**Town of Kittery
Planning Board Meeting
November 16, 2023**

ITEM 2—27 & 29 Wentworth—Site Plan — Preliminary Review

**Re: Site Plan Review
Tax Map 9, Lots 37 & 38
27 & 29 Wentworth Street
P5431**

Plan View
Scale - 1" = 16ft

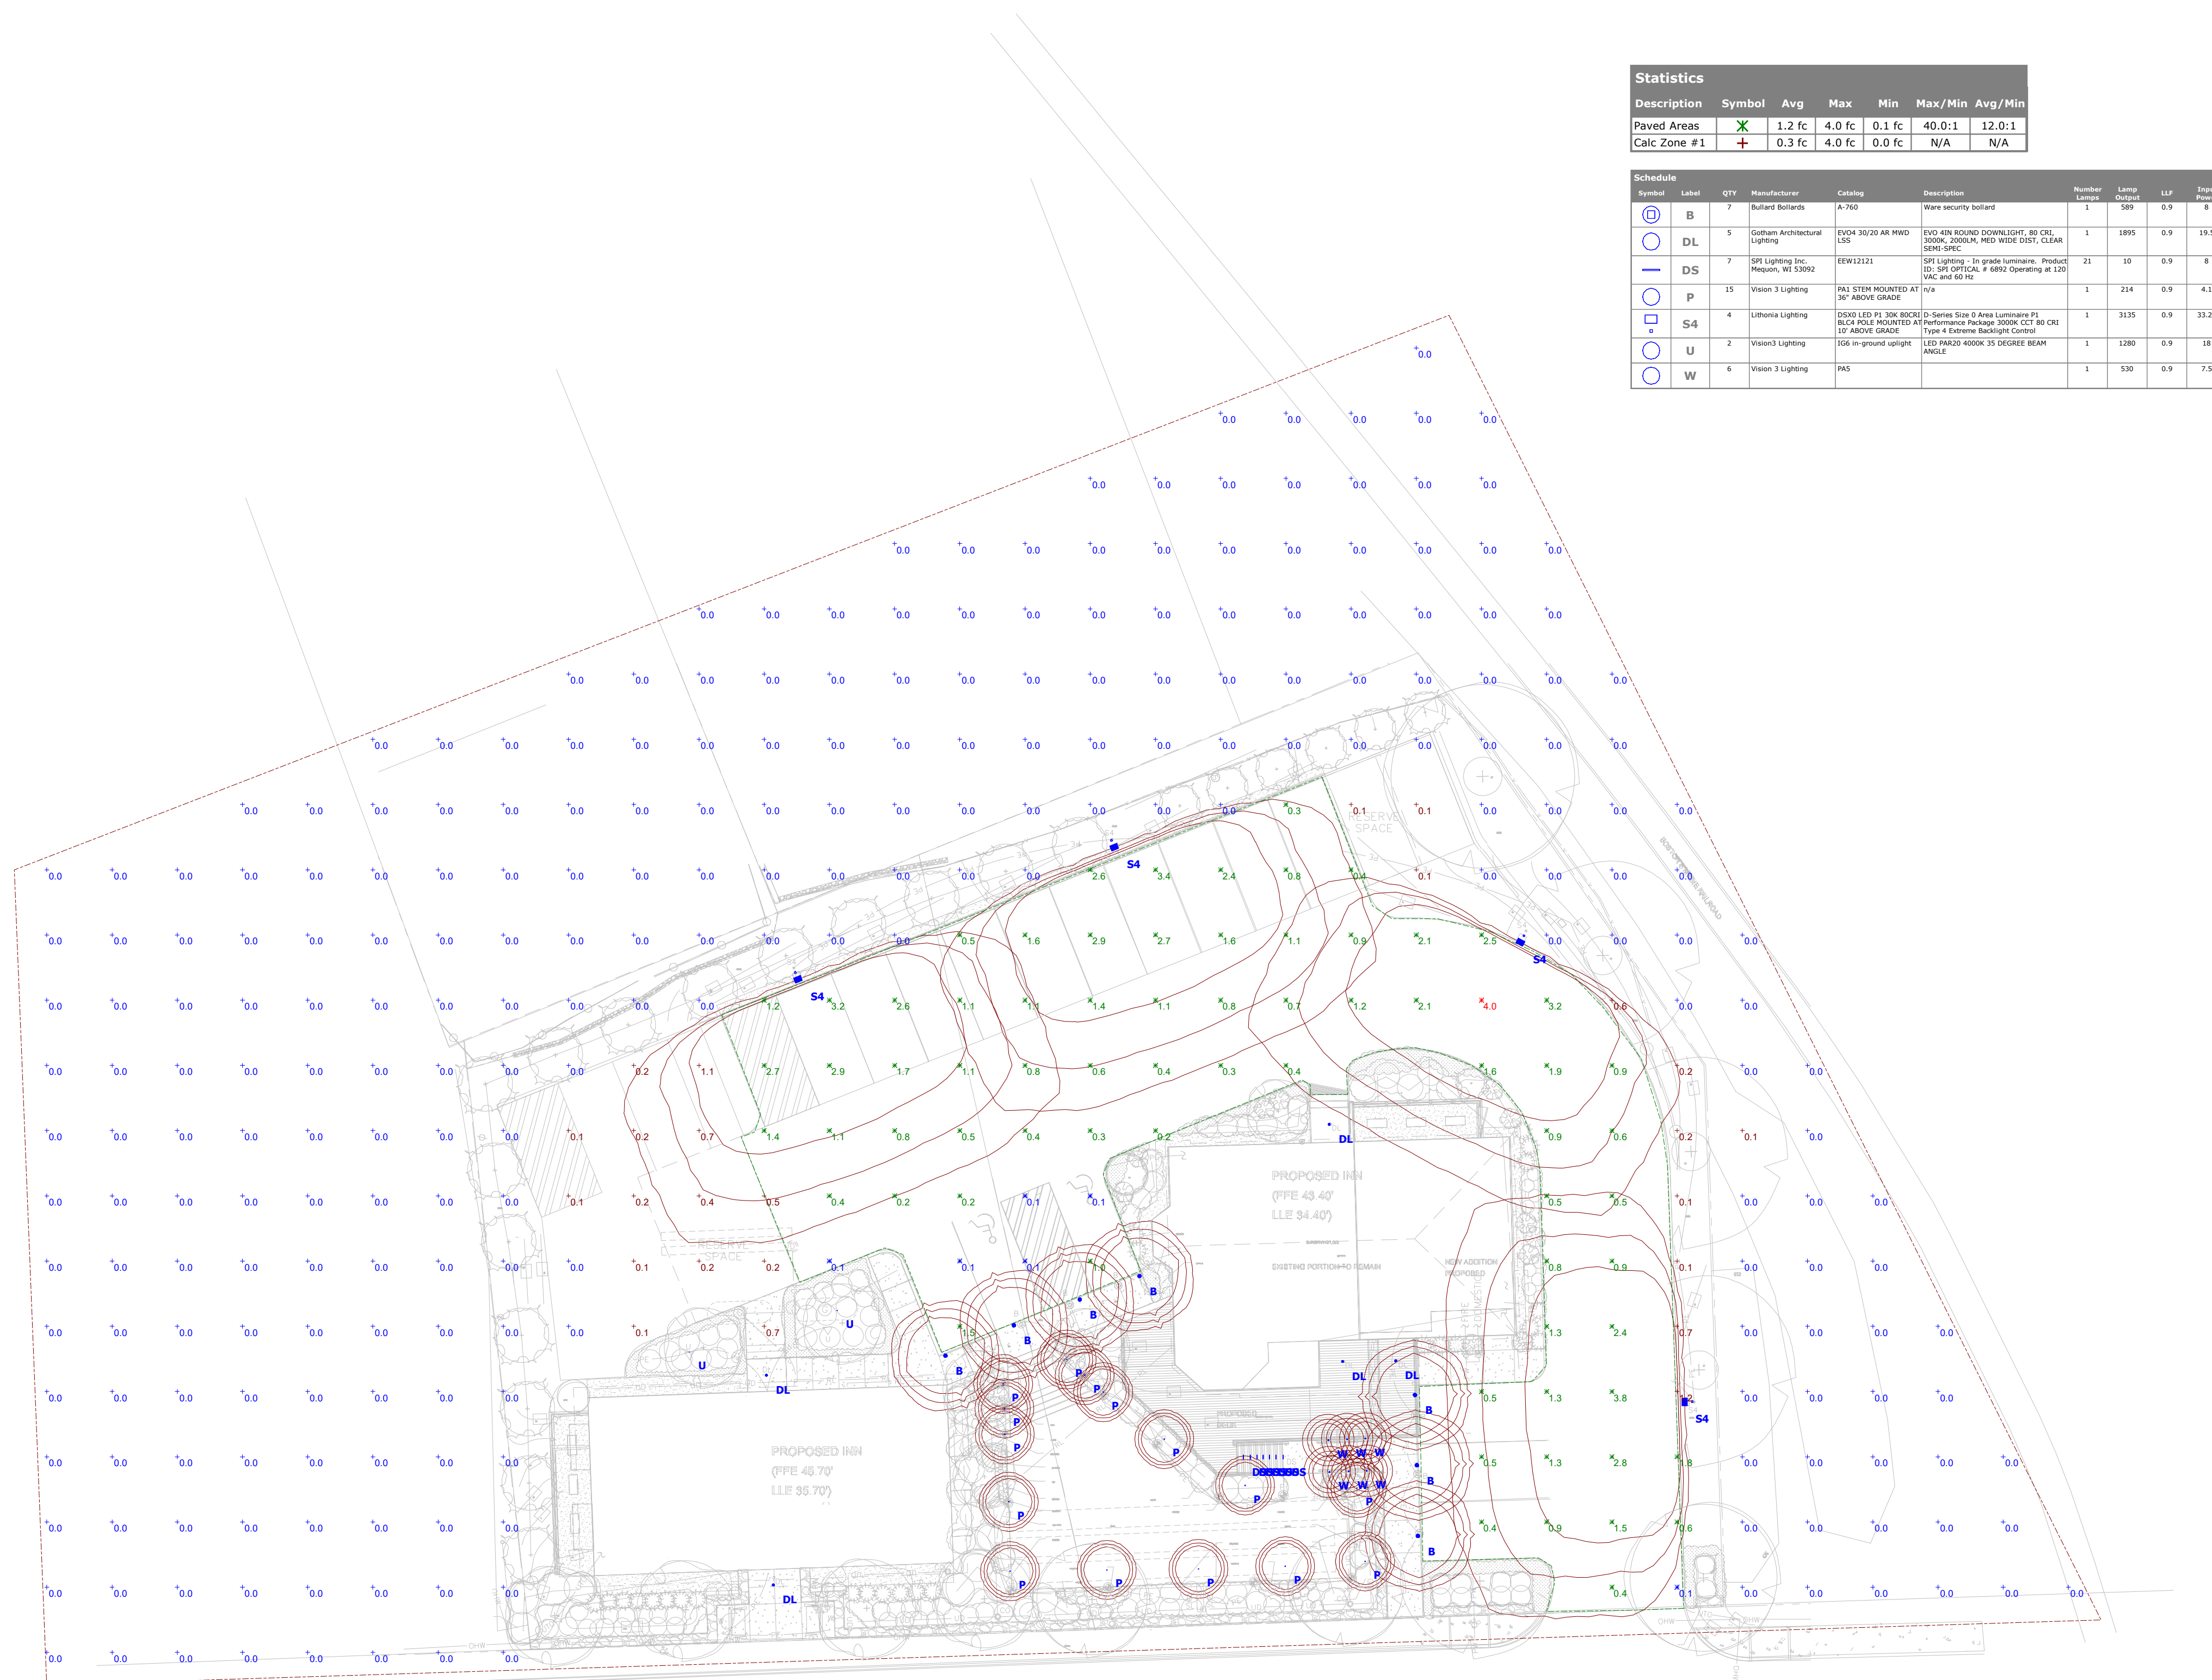
The lighting plan appears to indicate glare beyond the property line on Wentworth Street from the inn on Lot 37. Alternative lighting should be considered to meet the ordinances. **Altus: New lighting plan has been provided.**

Post-Development Drainage Area Plan

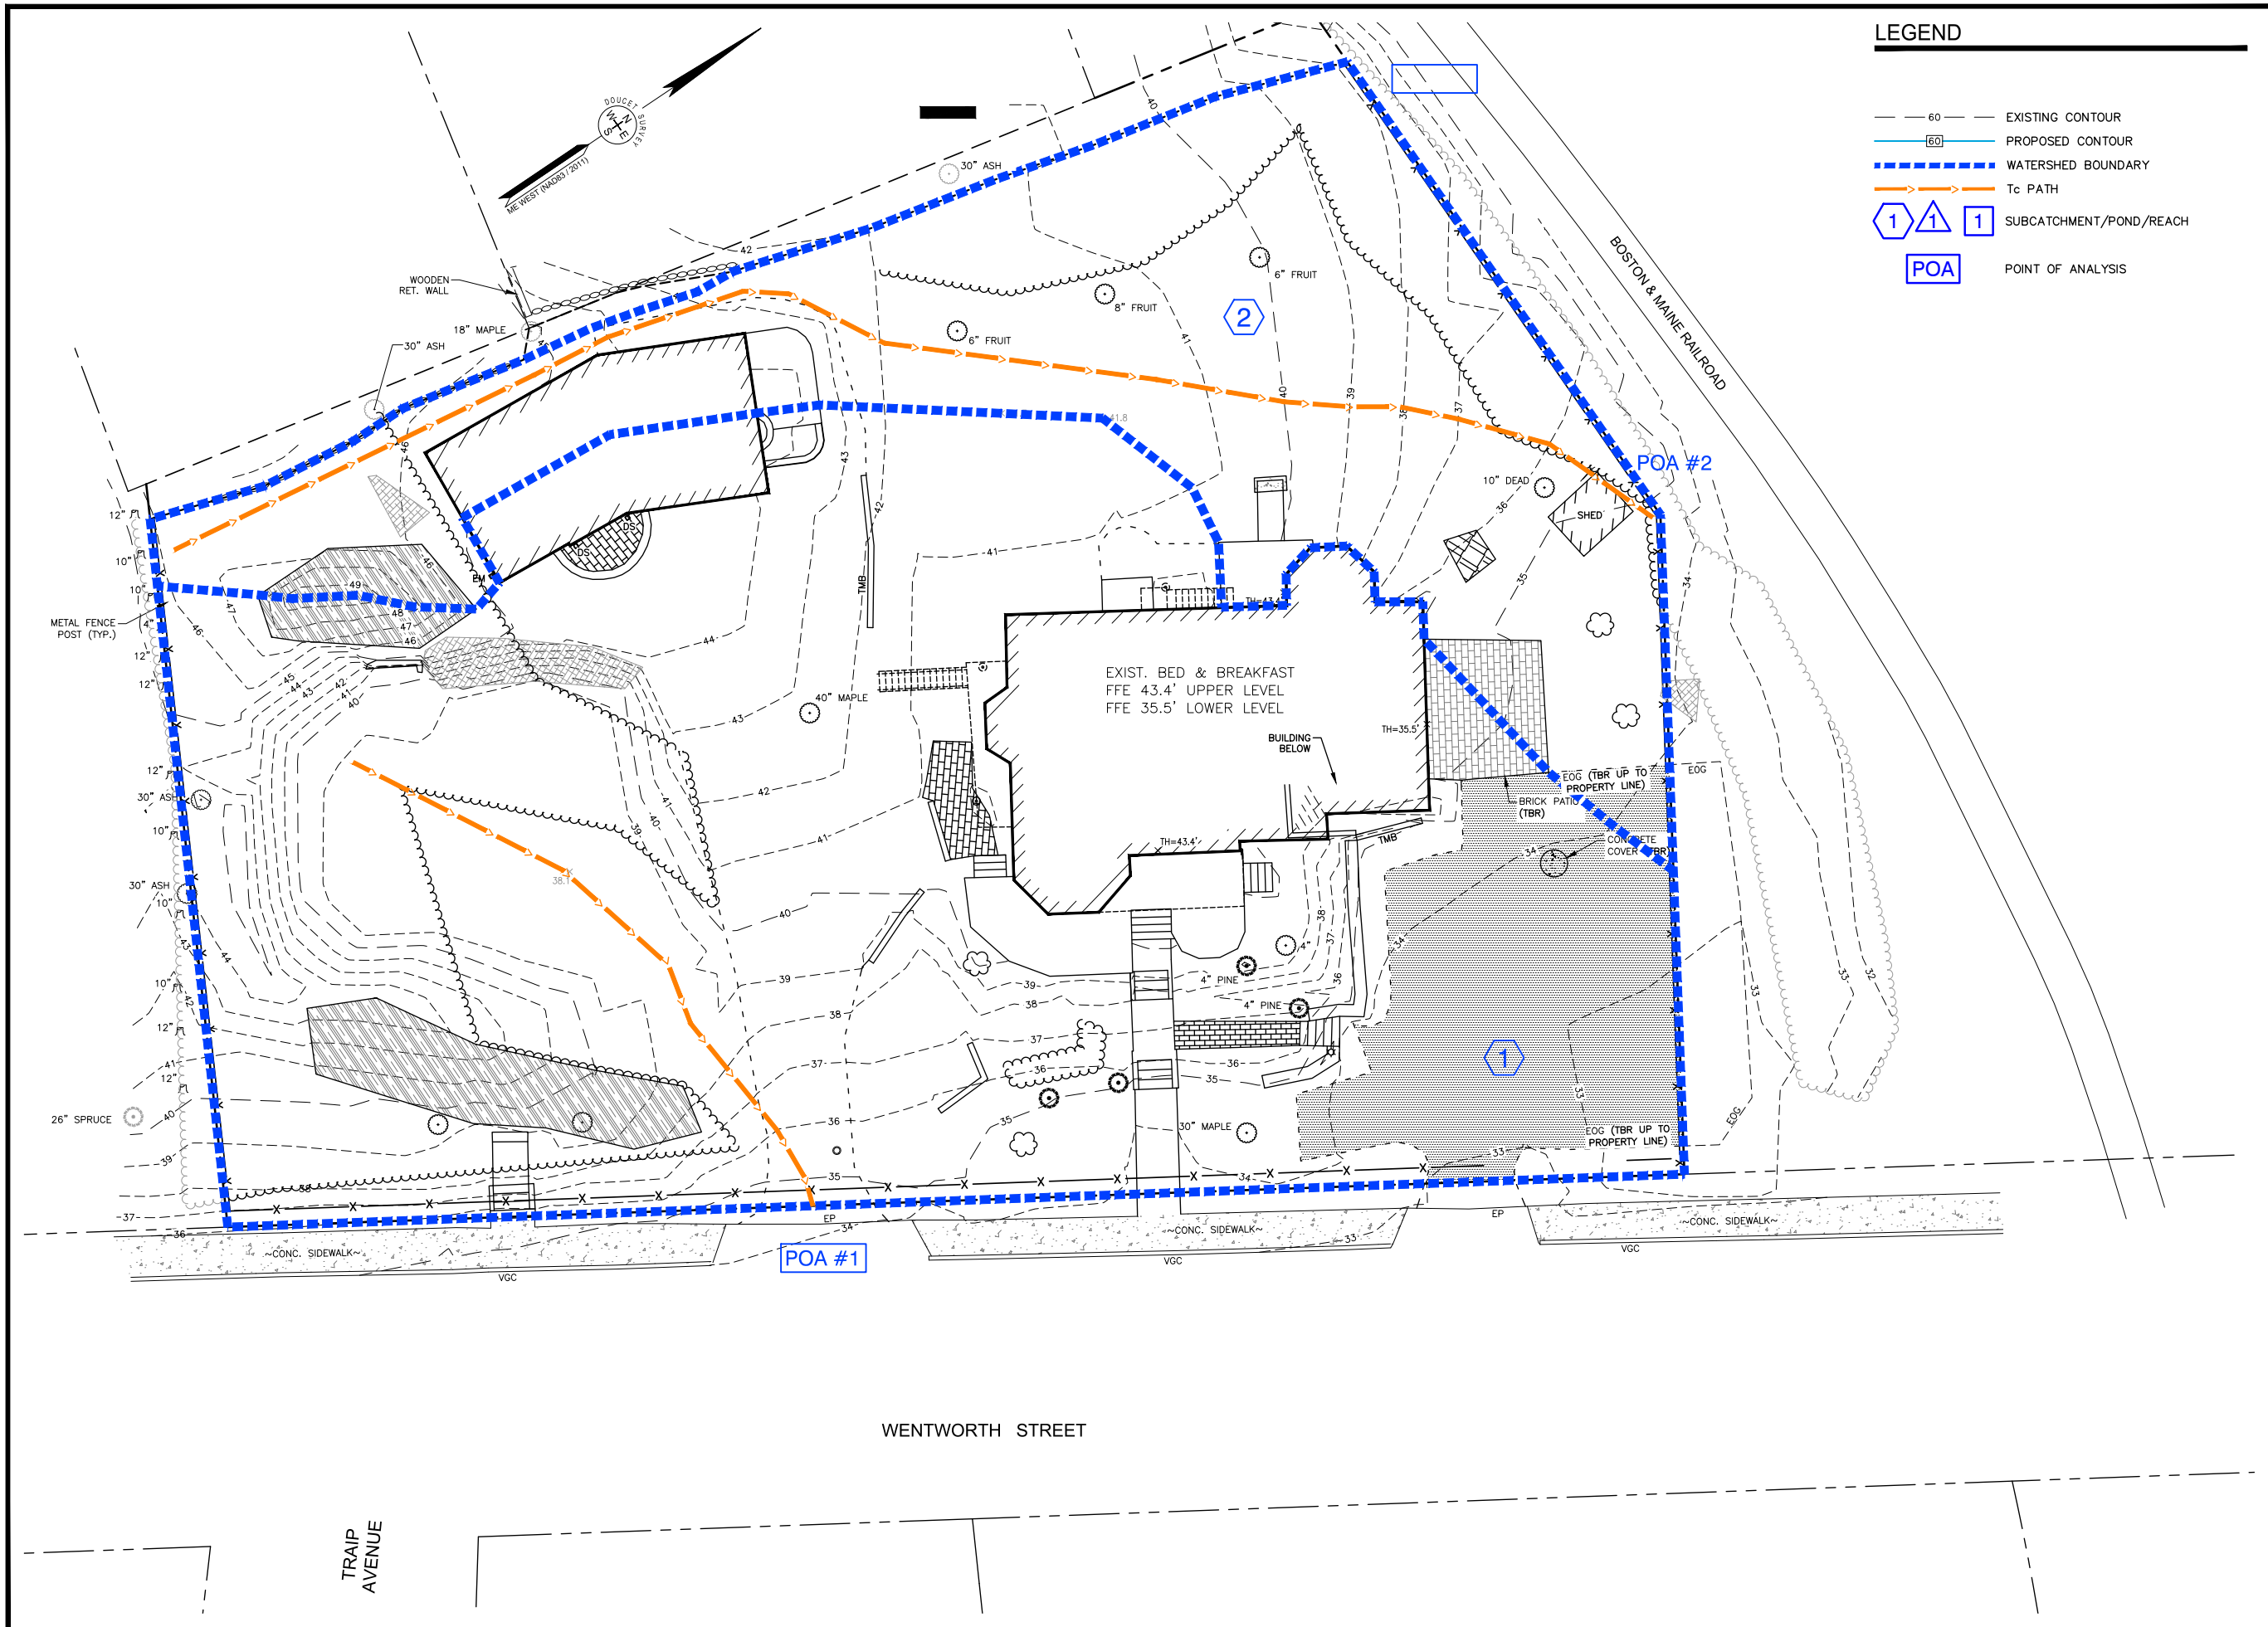
4. The Tc path for Subcatchment 11 should be shown on the Post-Development Drainage Area Plan. **Altus: Tc path has been added.**
5. Ponds should be labeled on the Post-Development Drainage Area Plan. **Altus: Pond symbol has been added.**
